Inspection Report

Property Address:
28999 Front Street
Temecula, CA 92592

ADA Compliance Review Corp.

Date: 9/8/2006	Time: 12:12 PM	Report ID: 060908-1
Property: 28999 Front Street Temecula, CA 92592	Customer: Business Owner	Real Estate Professional: J. Dominic Coates Richard & Richard Construction

Fig. 6

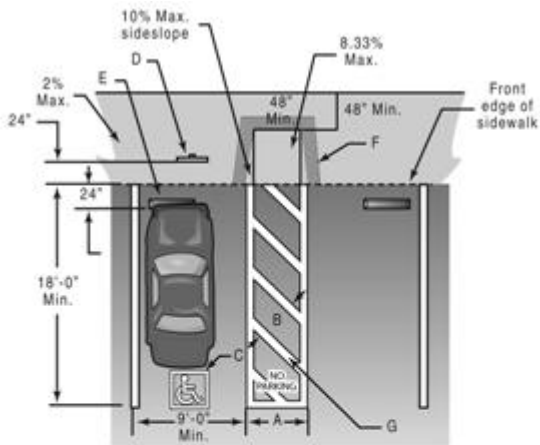
The dimensions of the parking spaces and access aisles are incorrect. Each parking stall must be 9 feet wide by 18 feet long. If two parking spaces share an access aisle, and van accessible aisles, the access aisle must be 5 feet wide. Some spaces are less than 9 feet wide, and accessible aisles are less than 5 feet wide.

I recommend having the spaces re-striped by a qualified contractor.

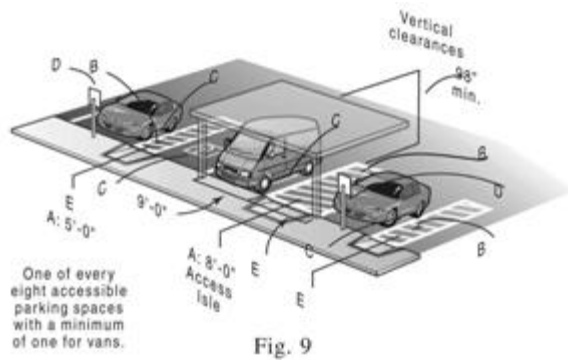
No proper van accessible space exists. The accessible aisle on the passenger side of the space assigned to be van accessible is not level, and cannot be considered part of the space.

One in every 8 stalls (but no less than one) shall be served by an access aisle 96 inches (8 feet) wide minimum placed opposite the drivers side and shall be designated Van-Accessible (CA T24 1129B.4.2 / ADA 4.1.2(5)(b)).

The van accessible sign is poorly installed. Recommend correcting the sign so that it is perpendicular to the parking space.

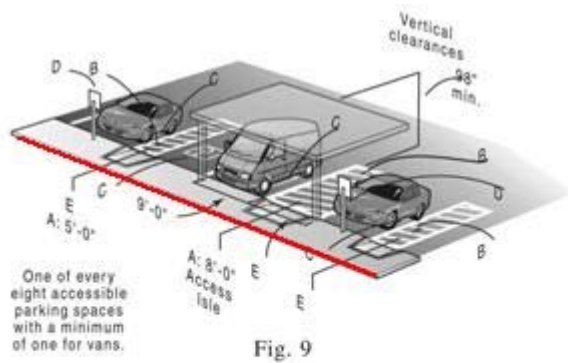
Wheelchair users must not be forced to go behind parked cars other than their own (CA T24 1129B.4.3) on new construction. The enforcing agency must determine whether compliance with this regulation is required. If you must comply with this, wheel stop curbs must be installed 24" from ramp to stop cars from encroaching onto pathway.

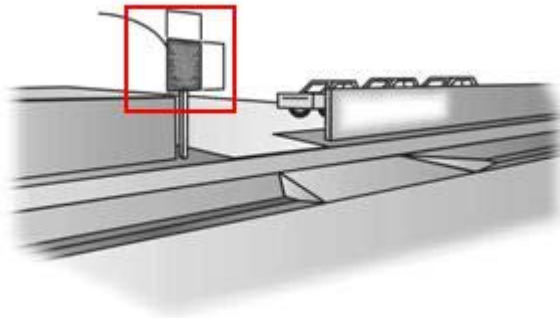
An additional sign shall also be posted in a conspicuous place at each entrance to off-street parking facilities, or immediately adjacent to and visible from each stall or space. The sign shall not be less than 17 inches by 22 inches (432 mm by 559 mm) in size with lettering not less than 1 inch (25 mm) in height, which clearly and conspicuously states the following:

“Unauthorized vehicles parked in designated accessible spaces not displaying distinguishing placards or license plates issued for persons with disabilities may be towed away at owner’s expense. Towed vehicles may be reclaimed at _____ or by telephoning _____.” Blank spaces are to be filled in with appropriate information as a permanent part of the sign.

Fig. 5

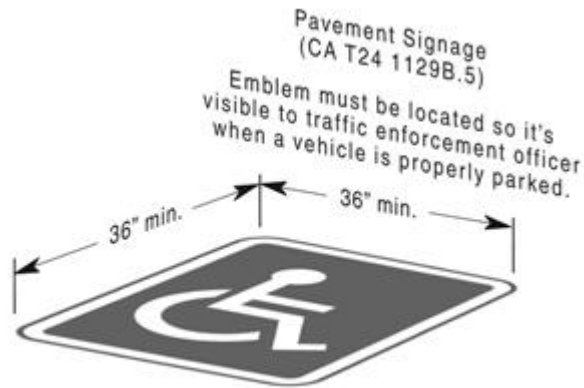
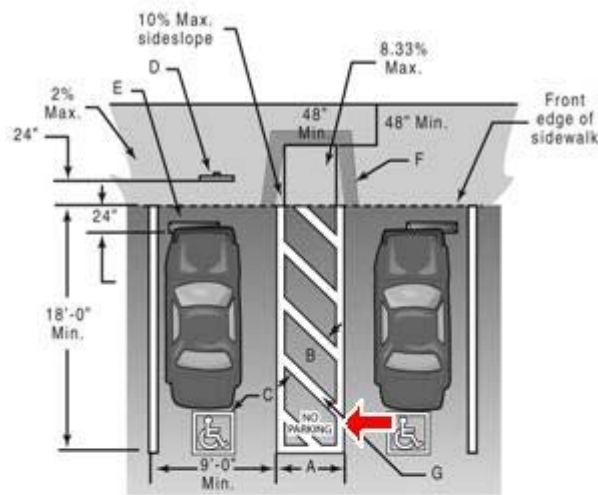
The surface of each accessible parking space or stall shall have a surface identification duplicating either of the following schemes:

1. By outlining or painting the stall or space in blue and outlining on the ground in the stall or space in white or suitable contrasting color a profile view depicting a wheelchair with occupant; or
2. By outlining a profile view of a wheelchair with occupant in white on blue background. The profile view shall be located so that it is visible to a traffic enforcement officer when a vehicle is properly parked in the space and shall be 36 inches high by 36 inches wide (914 mm by 914 mm).

The words "NO PARKING" shall be painted on the ground within each five-foot loading and unloading access aisle. This notice shall be painted in white letters no less than 12 inches high and located so that it is visible to traffic enforcement.

I recommend having a qualified re-striping company perform the required marking at the parking lot.

3.3 Picture 1

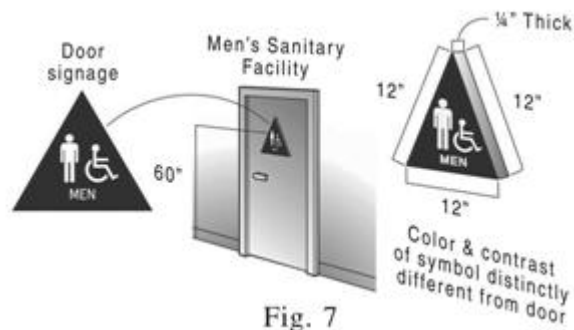
The hot water supply line is not insulated. This is a scalding hazard. Hot water and drainpipes accessible under lavatories shall be insulated or otherwise covered. There shall be no sharp or abrasive surfaces under lavatories. (1115B.2.1.2.2).

3.7 Picture 1

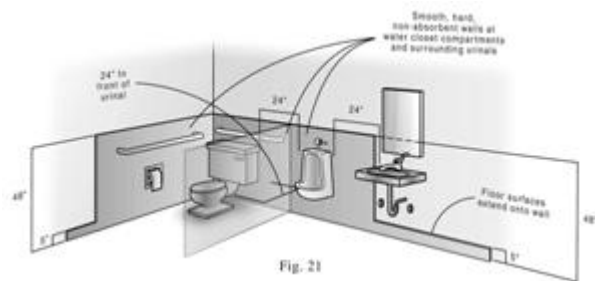
Toilet is mounted 19 inches from the side wall which is one inch more than allowed. Recommend relocating the toilet by a licensed plumber.

4.1 Picture 1

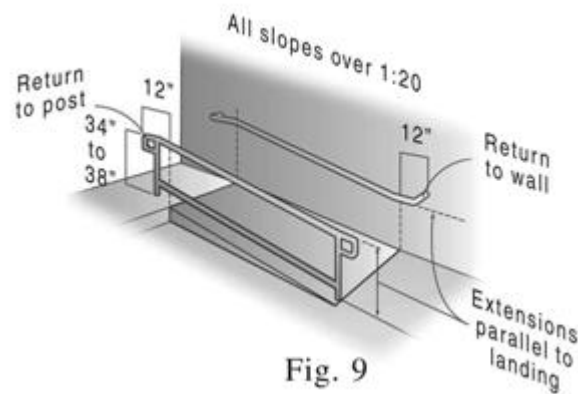
Pedestrian **exit** ramps shall have a minimum width of 48". The ramp at the rear entrance is less than 48 inches wide due to the installation of the handrails. Recommend widening ramp to minimum required width.

(b) Ramp with Turning Platform

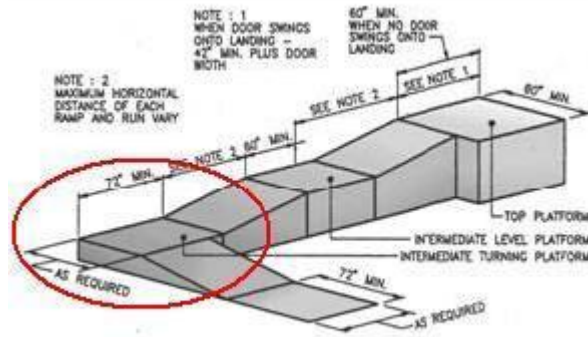
The landing at the bottom of the ramp, which changes directions, is too small (CA T24 1133B5.4.6). Intermediate and bottom landings at a change of direction in excess of 30 degrees shall have a dimension in the direction of ramp run of not less than 72 inches to accommodate the handrail extension.

Fig. 11

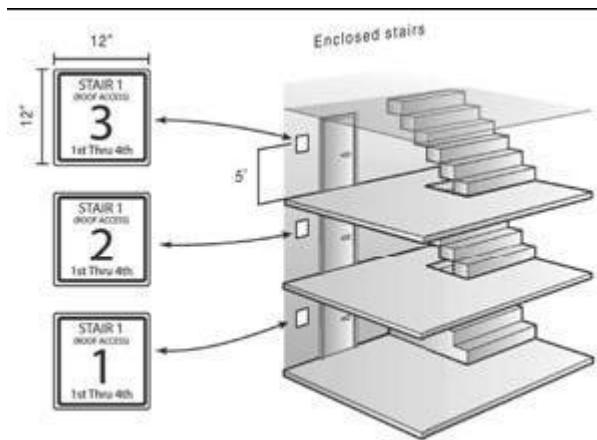
Enclosed stairways in buildings with two or more stories in height must have approved stairway identification signs located at each floor level in stairway. The signs must be 5 feet above the floor immediately adjacent to the door on the strike side. The sign must be positioned to provide uninterrupted visibility when the door is open or closed. (CA T24 1003.3.3.13/ADA 1133B.4.3)

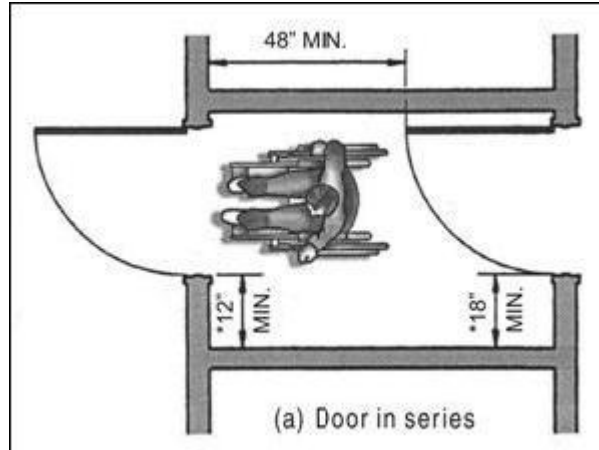
The doors in series at the bathrooms are not compliant. The minimum space between the hinged or pivoted doors in series shall be 48 inches plus the width of any door swinging into the space. Doors in series shall swing either in the same direction or away from the space between the doors. I recommend removing the inner door.

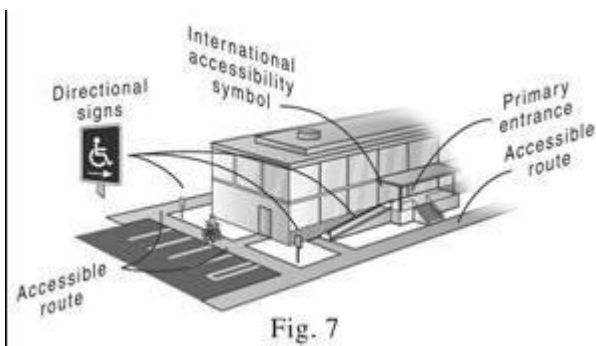
A sign with the international symbol of accessibility shall be at every primary entrance and every major junction indicating the direction along or to accessible features. (1127B.3/4.1.3)

Entrances that are accessible to and usable by persons with disabilities are identified with at least ONE International Symbol of Accessibility. Additional directional signs using the symbol are visible along approaching pedestrian ways. (1117B.5.8.1.2).

6.9 Picture 1

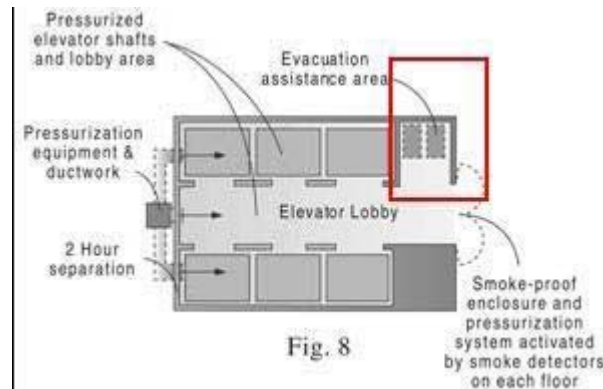
Several recessed doors exist in the building which do not provide adequate access to the individual suites. To remedy this, I recommend relocating the door to the front edge of the hallway so that adequate access (18 inches) is created at the latch side of the door.

Fig. 7

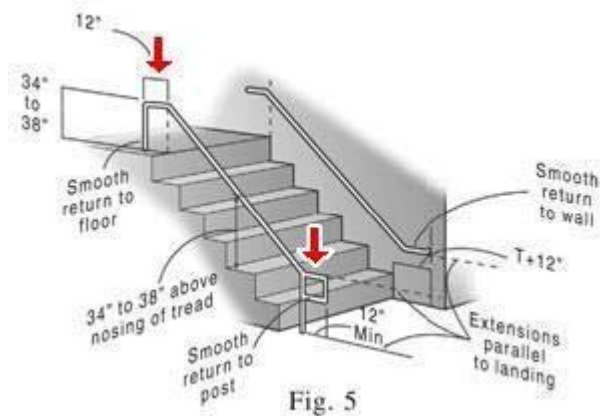
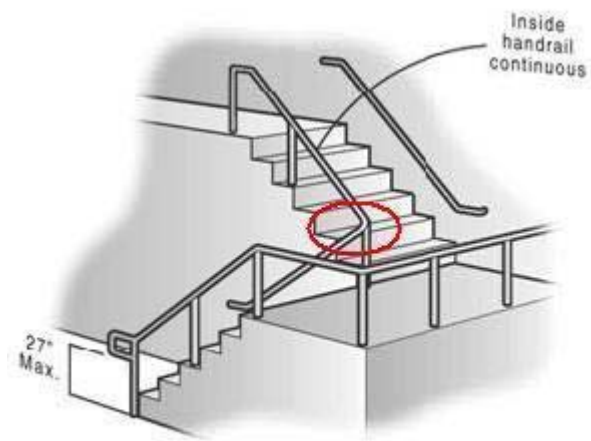
If handrails are not continuous, they shall extend at least 12 inches beyond the top riser and at least 12 inches plus the width of one tread beyond the bottom riser. At the top, the extension shall be parallel with the floor or ground surface. At the bottom, the handrail shall continue to slope for a distance of the width of one tread from the bottom riser; the remainder of the extension shall be horizontal.

Checking the load capability of the handrail is beyond the scope of this inspection. I recommend having the wood handrail replaced with a metal rail.

Fig. 15

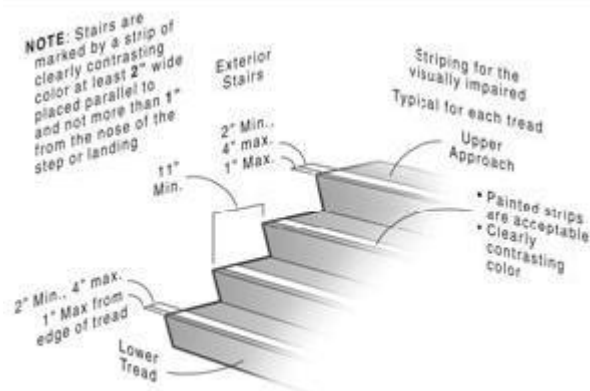
Exterior striping is missing at the stair treads landing(s). The upper approach and all tread of each stair shall be marked by a strip of clearly contrasting color at least 2 inches wide placed parallel to, and not more than 1 inch from, the nose of the step or landing to alert the visually impaired. The strip shall be of material that is at least as slip resistant as the other treads of the stair. A painted strip is acceptable.(1120A.4)

Fig. 15

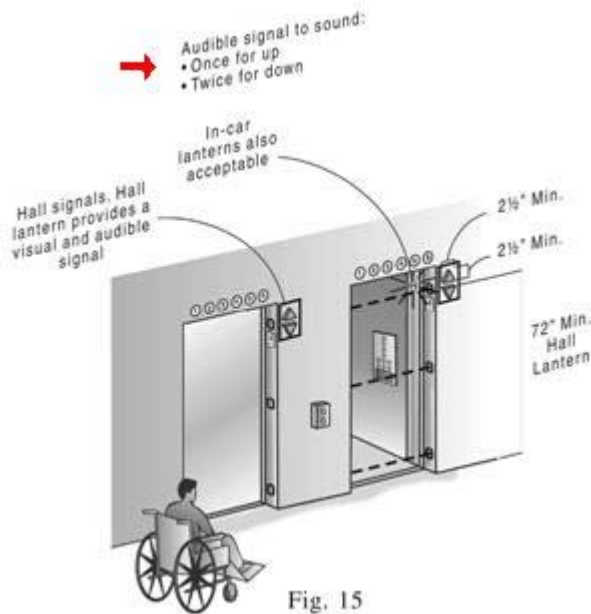
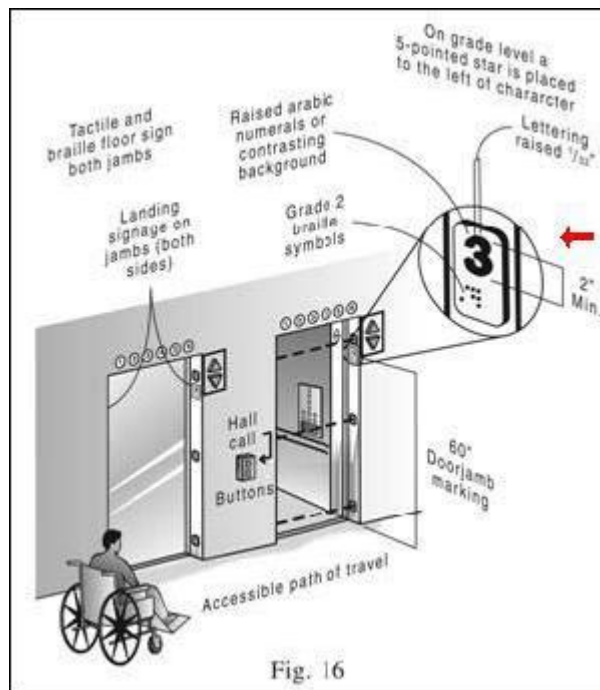
The lantern and audible signal did not function.

A visual and audible signal shall be provided at each hoistway entrance indicating to the prospective passenger the car answering the call and its direction of travel. The visual sign for each direction is a min. of 2 1/2 inches high by 2 1/2 inches wide and visible from the proximity of the call button. (CA T24 1116B.1.14/ADA 4.10).

The audible signal sounds once for the up direction, and twice for the down direction or sounds a configuration that distinguishes between up and down travel.

Panel Detail
Fig. 12

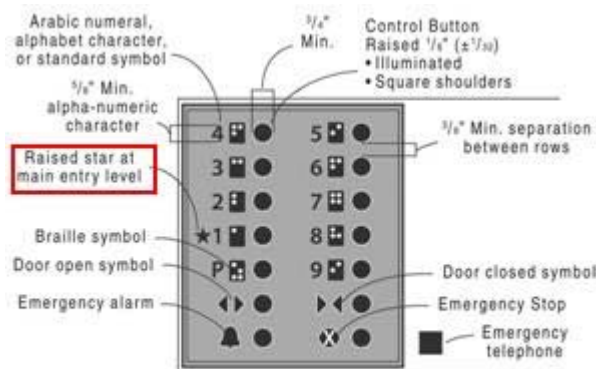
A Star is required adjacent to the ground floor button.
